Access Compliance Report

Public Rights-of-Way

(Curb Ramps)

Intersection ID: 11001	Main Street: SLAGLE_DR	Cross Street: TIPPERARY_PL	Location: S
ADA ID: 81B0DF7E6C27	Ramp Type: BlendTrans1	Initial Pass/Fail: Fail	Overall Compliance: No
			Severity Score: 21.25

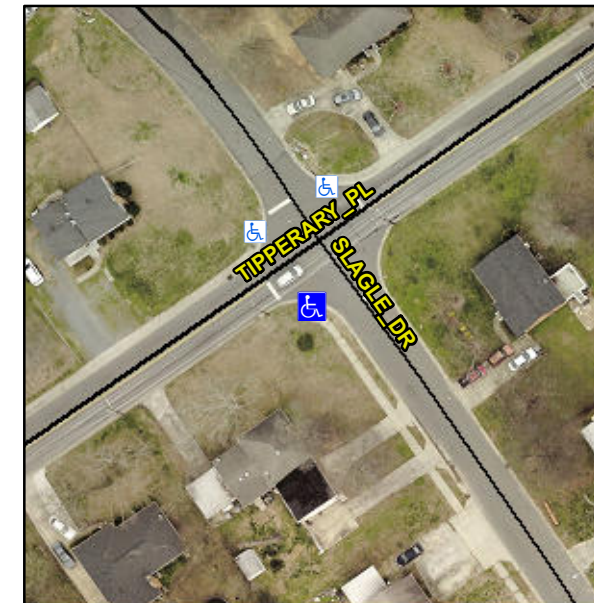
R304.5.1, R304.5.3

Compliance	Description	Data	Compliance	Description	Data
N/A	Ramp Length (in)	47.0	Yes	BlendTrans Slope (%)	4.3
No	Ramp Width (in)	47.0	No	BlendTrans XSlope (%)	6.4
N/A	Flare Type LT	N/A	N/A	Flare Type RT	N/A
N/A	Flare Slope LT (%)	N/A	N/A	Flare Slope RT (%)	N/A
N/A	Flare Traversable LT?	N/A	N/A	Flare Traversable RT?	N/A
N/A	Landing Length (in)	N/A	N/A	DWS Provided?	N/A
N/A	Landing Width (in)	N/A	N/A	DWS Contrast?	N/A
N/A	Landing Slope (%)	N/A	N/A	DWS Length (in)	N/A
N/A	Landing X Slope (%)	N/A	N/A	DWS Full Width?	N/A
N/A	Landing Curb? (Y/N)	N/A	N/A	DWS Offset (in)	N/A
N/A	Shared Landing?	N/A			
N/A	Gutter Ponding?	N/A	N/A	Gutter Slope (%)	N/A
N/A	Gutter Lip Ht (in)	N/A	N/A	Gutter X Slope (%)	N/A
N/A	Painted X Walk1?	No	N/A	Painted X Walk2?	N/A
	X Walk 1 Direction	To NW		X Walk 2 Direction	N/A
	X Walk 1 Width (in)	N/A		X Walk 2 Width (in)	N/A
	X Walk 1 Slope (%)	1.1		X Walk 2 Slope (%)	N/A
	X Walk 1 X Slope (%)	5.5		X Walk 2 X Slope (%)	N/A

Remove & Replace Curb Ramp With Two New Directional Ramps or Equivalent.
